OPERATING AND SERVICE MANUAL

VECTOR VOLTMETER 8405A

HEWLETT  PACKARD

For instruments with serial prefix above 946-, a "Manual Changes" sheet is included with this manual. The necessary changes required to adapt this manual for instruments with serial prefix 838 and below can be found in Appendix I.

Figure 7-17(b). Schematic Diagram, Automatic Phase Control Section (Part 2) Sampling Pulse Generator 7-17/7-18

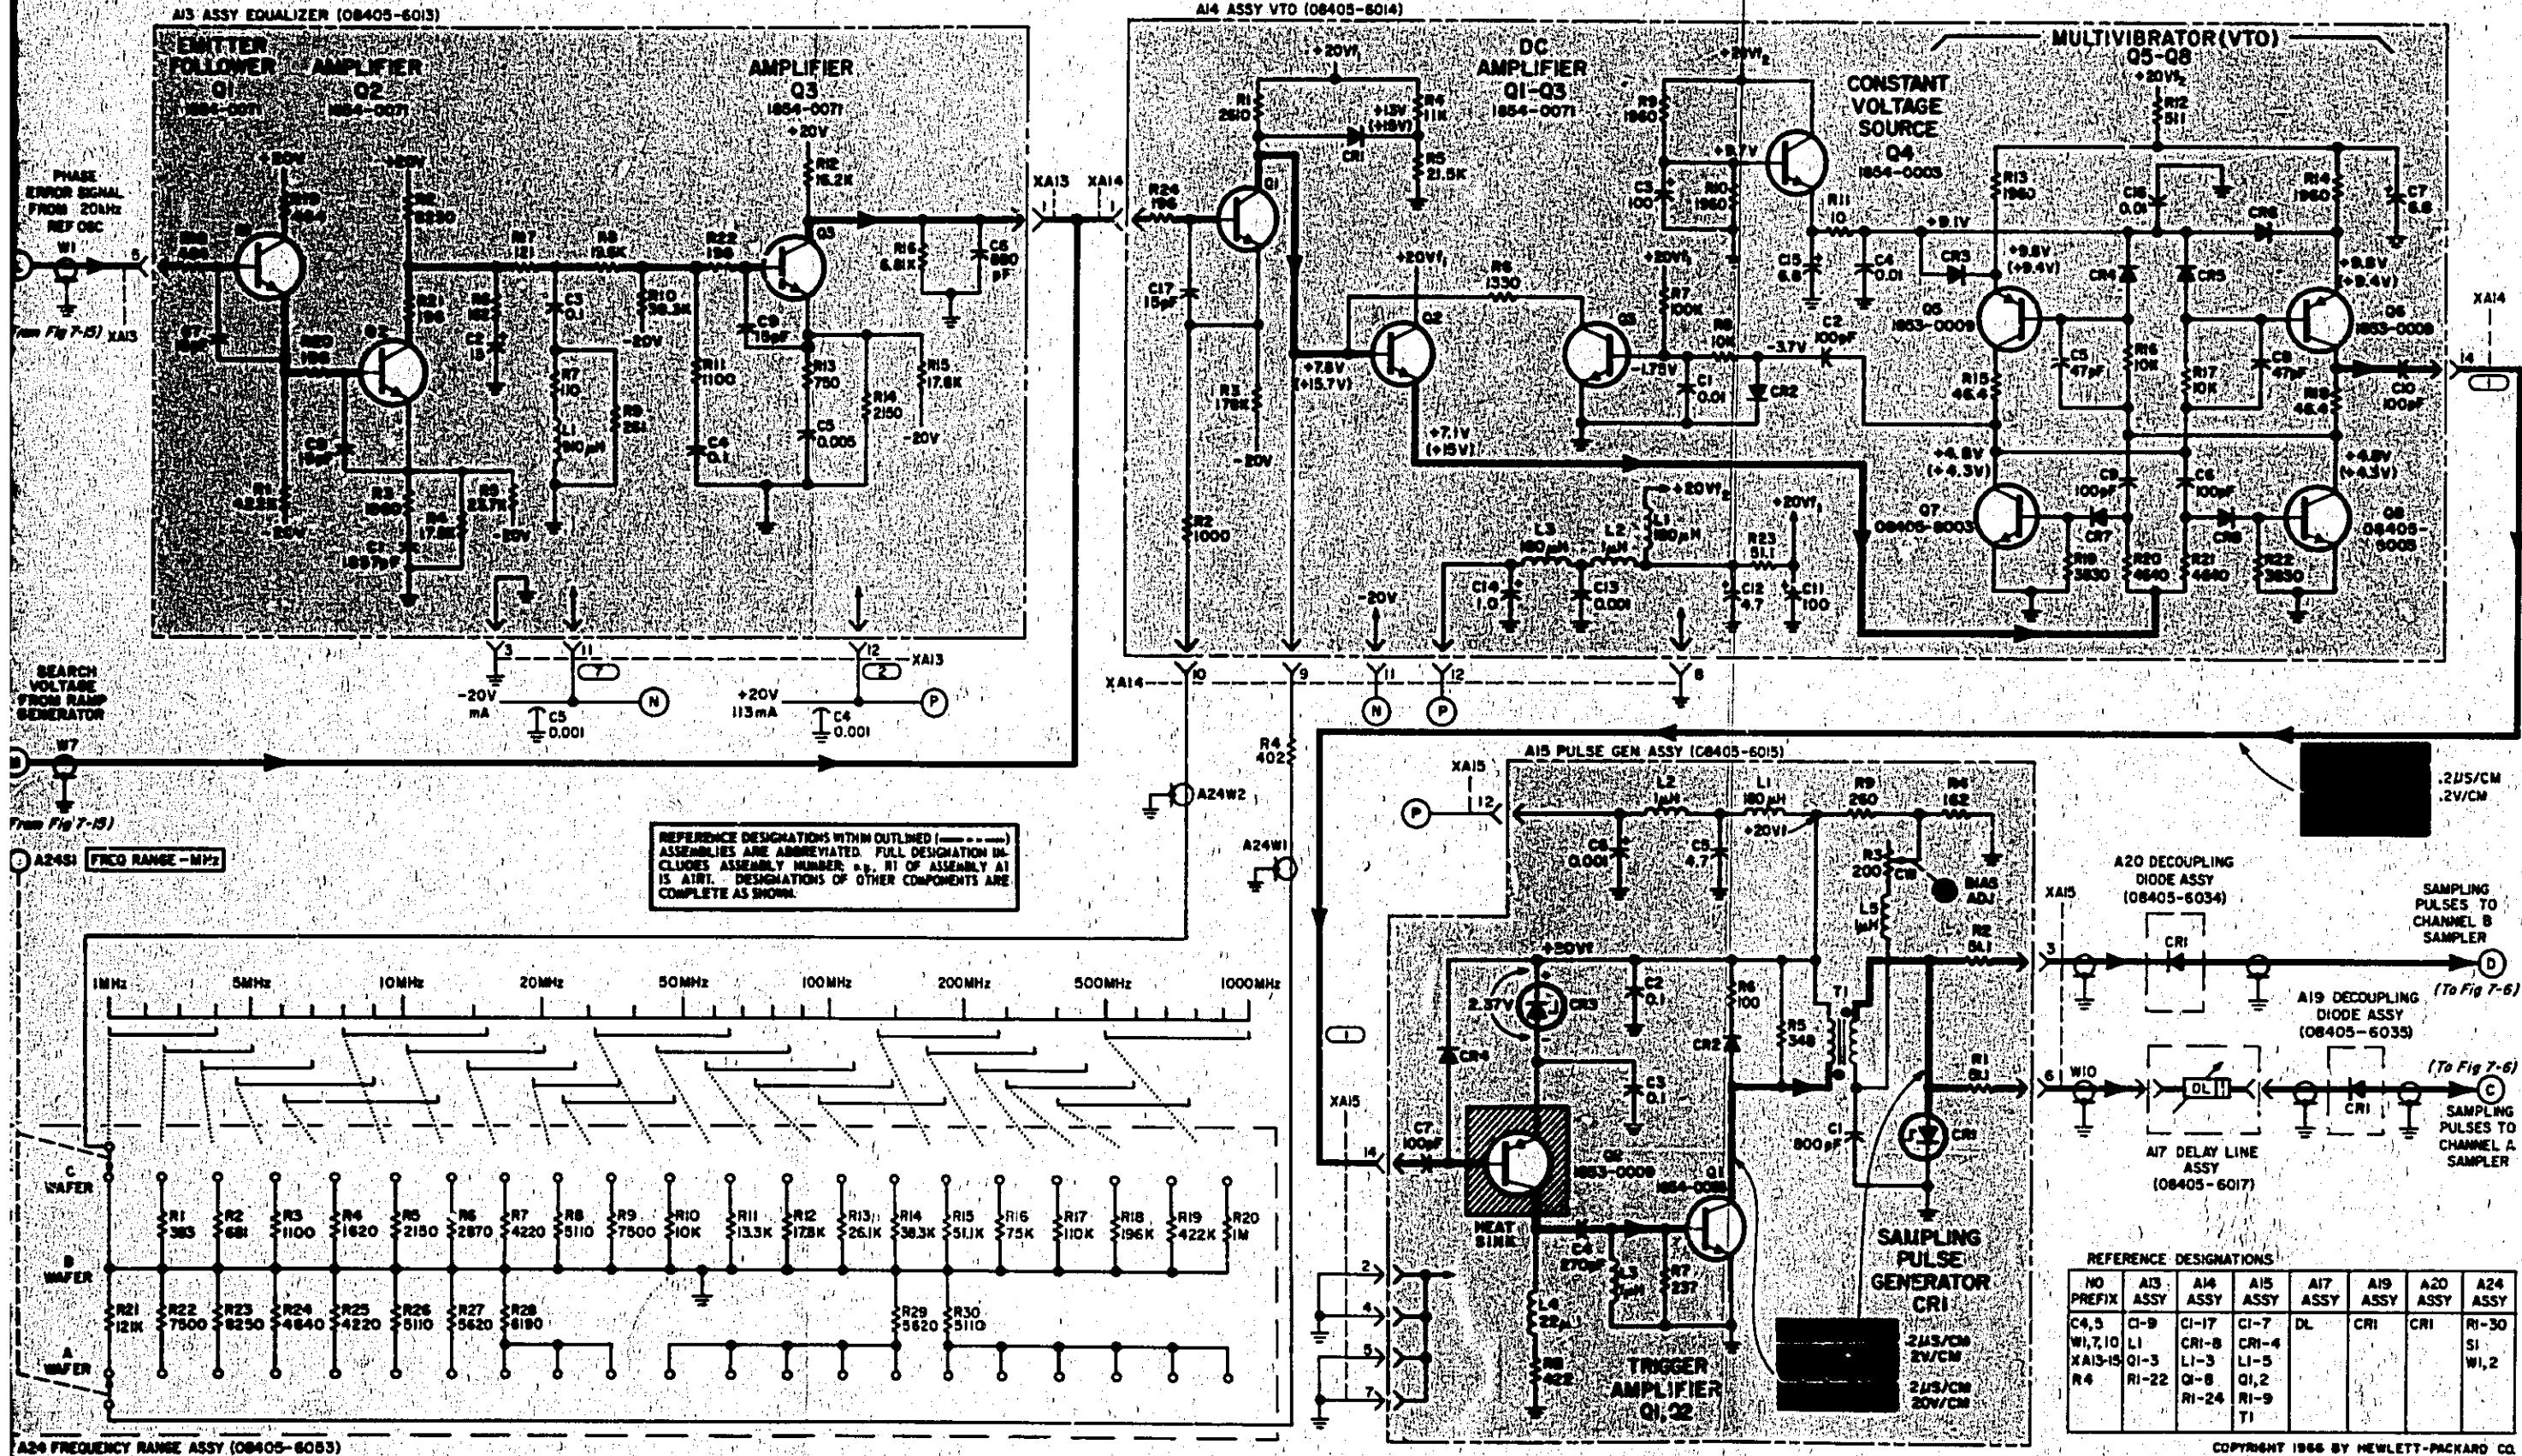
Figure 7-17(b):
Change A19 to 08405-60072.
Add A19CR2 in series with A19CR1, cathode toward A17.
Change A20 to 08405-60071.
Add A20CR2 in series with A20CR1, cathode toward XA15-3.

Figure 7-17(b):
Change A15R9 to 333 Ohms.

Figure 7-17(a):
Replace the part number 08405-6053 which identifies the A24 Frequency Range Assy with this note: See Table 6-1 for the current assembly number.
Figure 7-17(b) of Change 17:
Replace the part number 08405-6053 which identifies the A24 Frequency Range Assy with this note: See Table 6-1 for the current assembly number.

Figure 7-18(b). Schematic Diagram. Power Supplies

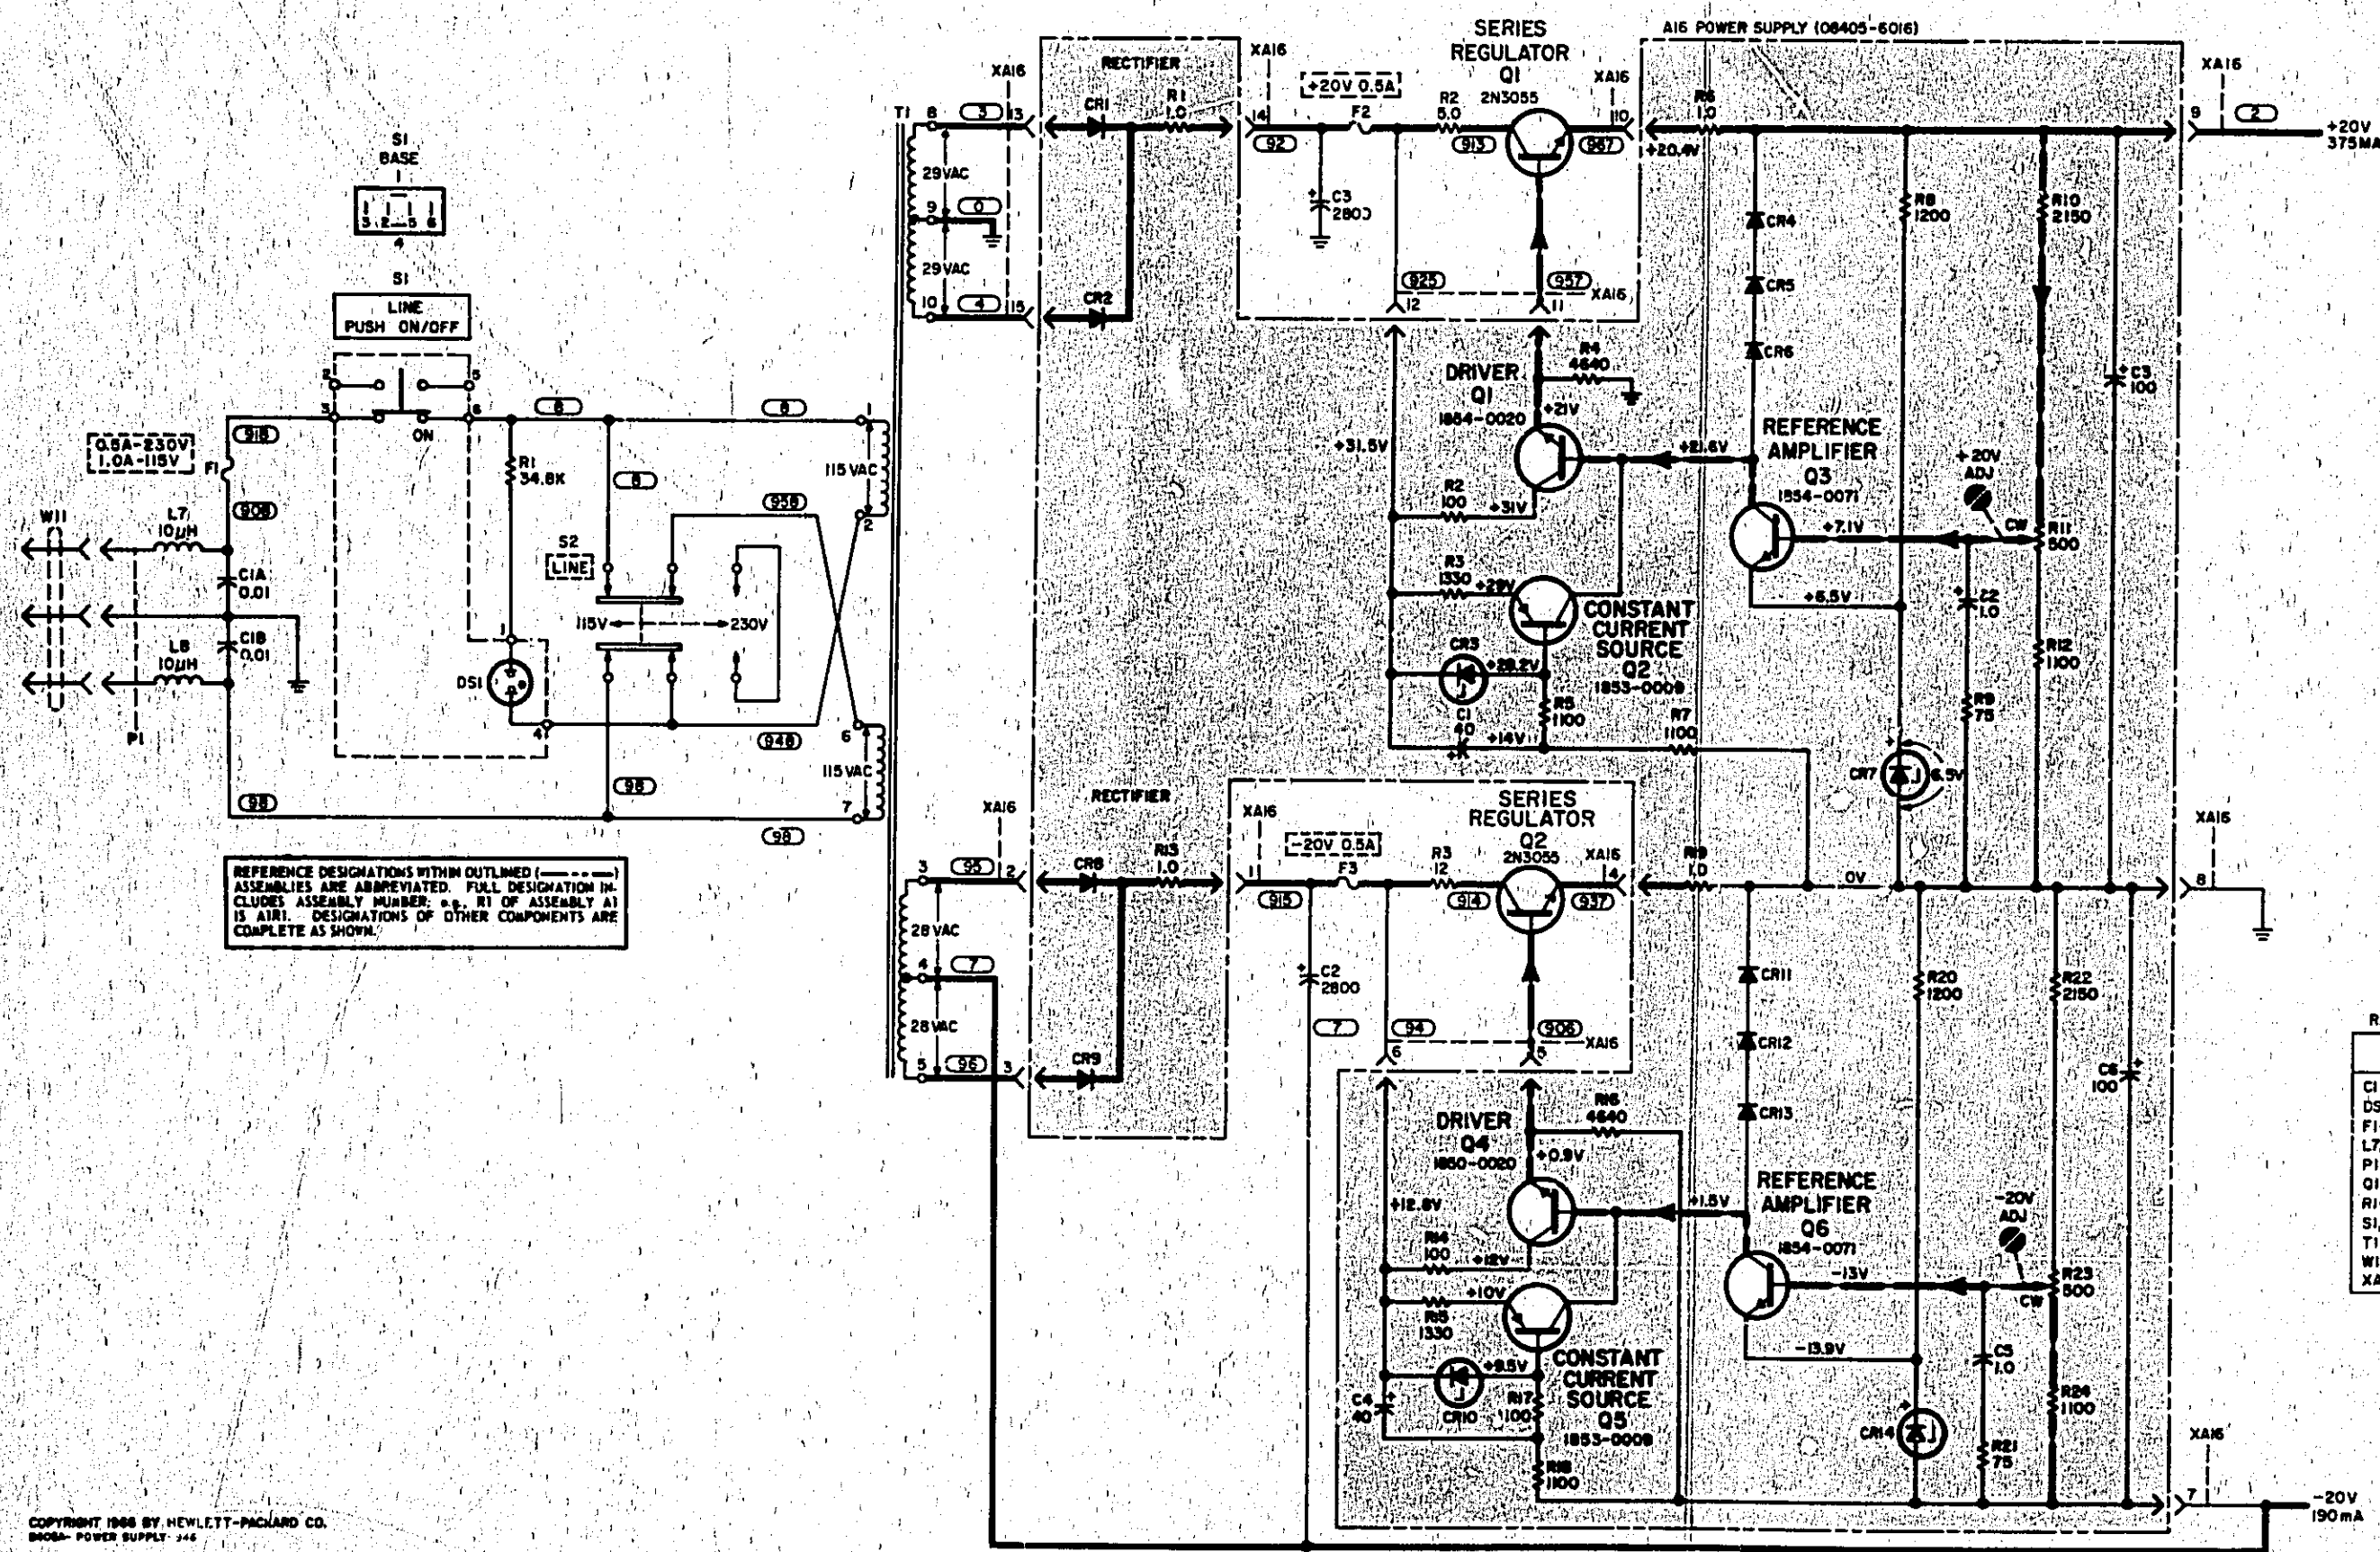
Figures 7-18(a) and 7-18(b):
Change R1 to 46.4K.

Figure 7-18(b):
Add C7. Anode to ground, cathode to base of Q5.

Figures 7-18(a) and 7-18(b):
Change primary power circuit per Figure 7-18 in this change sheet (CHANGE 7).

Figure 7-18(b):
Add A16C8, .047 uF, between anodes of CR1 and CR2.
Add A16C9, .047 uF, between anodes of CR8 and CR9.

Figure 1. Partial Schematic of AB Phase Meter Assy (08405-6008)

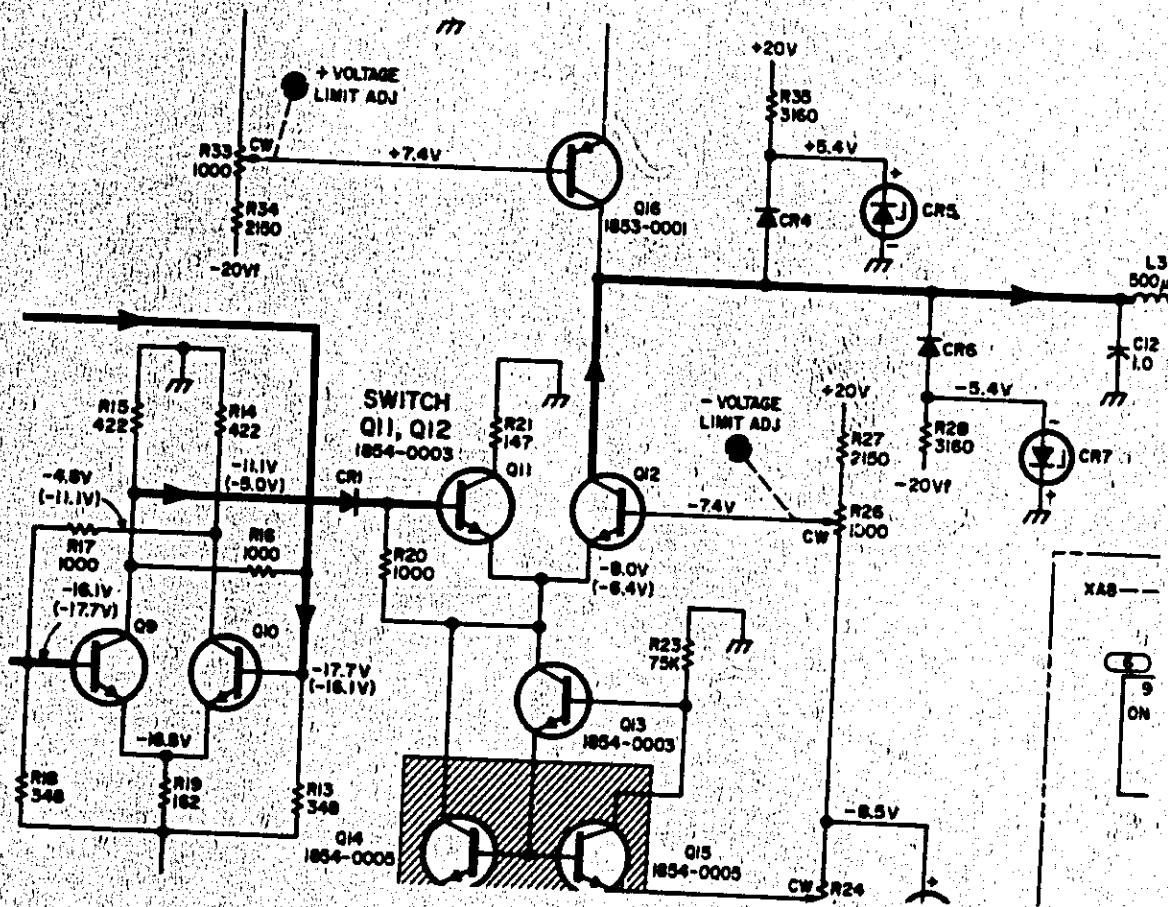
CHANGE 9: AB Phase Meter Assy is different (see Figure 1 below) than shown in Figure 7-11.
 Table 6-1, Pages 6-8, 6-9 and 6-10,

Change Resistors ABR27, R34,

To: 0698-0084 R:FXD MET FLM 2.15K OHM 1% 1/8 W
 From: 0698-3101 R:FXD MET FLM 2.87K OHM 1% 1/2 W

Figure 2. Schematic of A11 IF Sampler Assy (08405-6011)

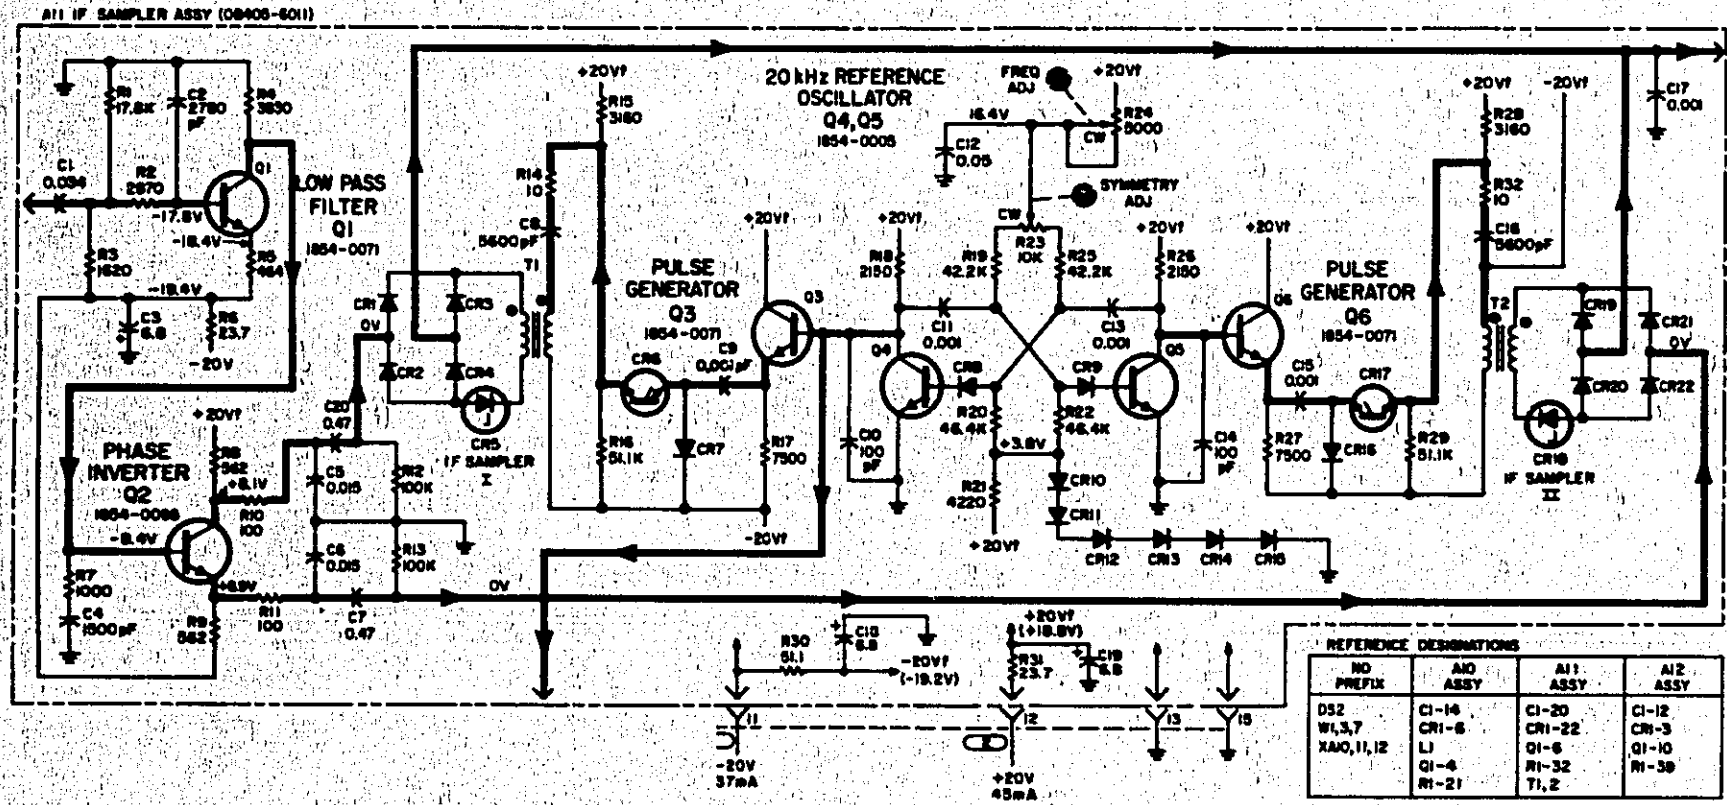
CHANGE 10: a.) All Sampler Assy 08405-6011 is different (see Figure 2) than shown in Figure 7-15.

b.) In the event of A12R27 failure, it is recommended that the value be changed.

From: 0698-3446 R:FXD 383OHM 1% 1/8W
 To: 0686-4315 R:FXD 430Ω 5% 1/2W

P/O Figure 7-15(b). Schematic Diagram, Automatic Phase Section (Part 1) (CHANGE 11)

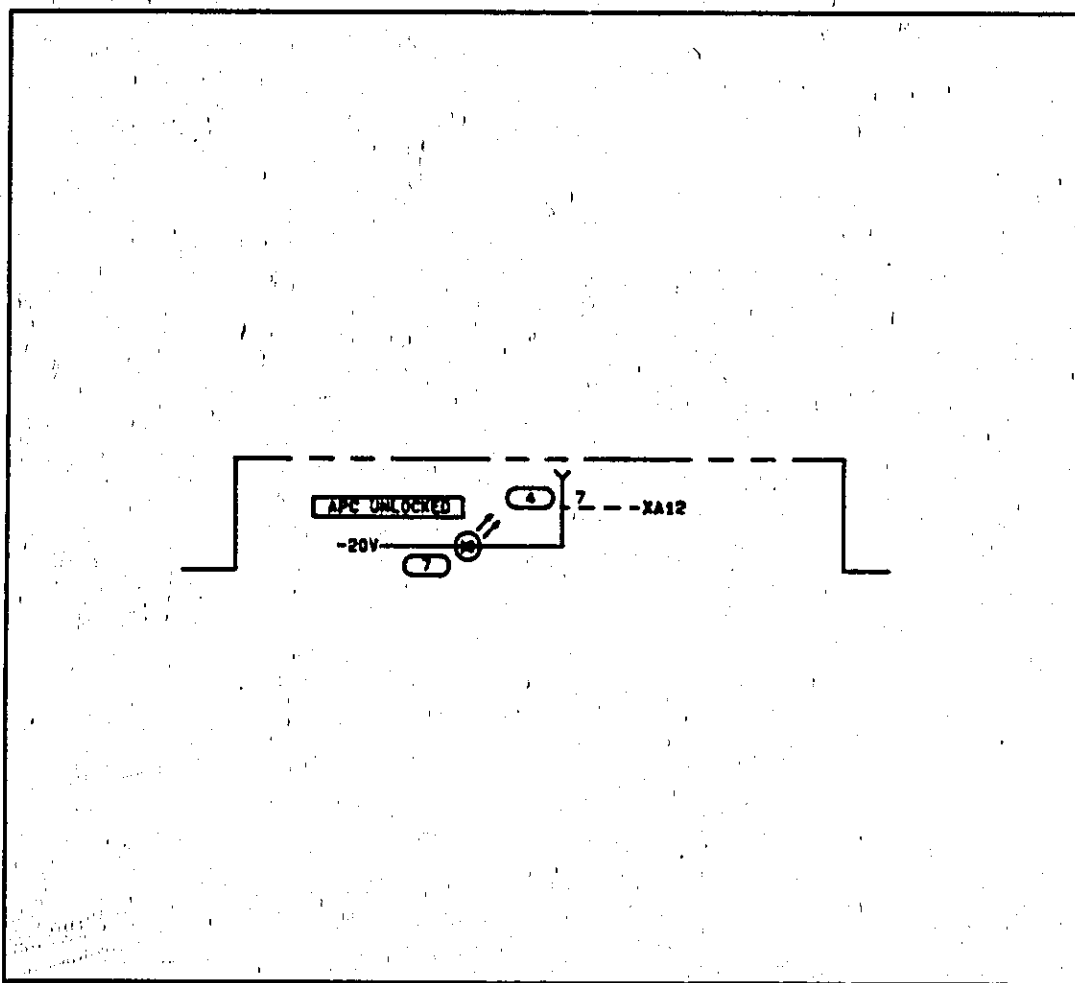
Change the A12DS2 symbol using the partial schematic in this document [P/O Figure 7-15(b) (CHANGE 11)].
